Building Conservation comments

File Ref: 24/01466/FPH & 24/01467/LBC

Address: Hexton Manor, Hexton, Hitchin, Hertfordshire SG5 3JH

- **24/01466/FPH** - Erection of garage outbuilding, following demolition of existing service outbuilding.
- **24/01467/LBC** - Erection of garage outbuilding, following demolition of existing service outbuilding.

File/Reference: 00/00713/1HH
Subject: Detached Garage Block & Store

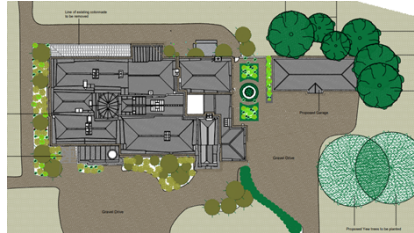
As Codicote Lodge is a substantial country house, it would be quite appropriate for it to have a comparably large vehicle storage building – a modern garage block being equivalent to an historic stables and carriage house. Therefore, I see no basic conservation objections to the overall size of block proposed.

I do, however, wonder about the first floor projections that add substantial bulk to the building without any apparent use. I would, therefore, suggest omitting these. As other aspects of design – bearing in mind the large size of the block – I would advise using materials and detailing that relate more to the house than the existing small rear domestic ancillary structures i.e. slate roofing and all gault brick detailing rather than any contrasting red brick.

The other major issue is the siting of the block. As discussed, I see no building conservation problems with this. The garaging would be close enough to the house to be practical and reflect possible historic relationships of main house and outbuildings, particularly as it is also closest to the domestic offices rather than the formal living part of the house.

Setting into existing well-established planting would have the added benefits of 'softening' its overall impact on the site though this will need to take account of ensuring the retention of any important trees. If the latter were compromised in any way such as to suggest any re-siting of the garage, I would wish to be involved in any relevant considerations.
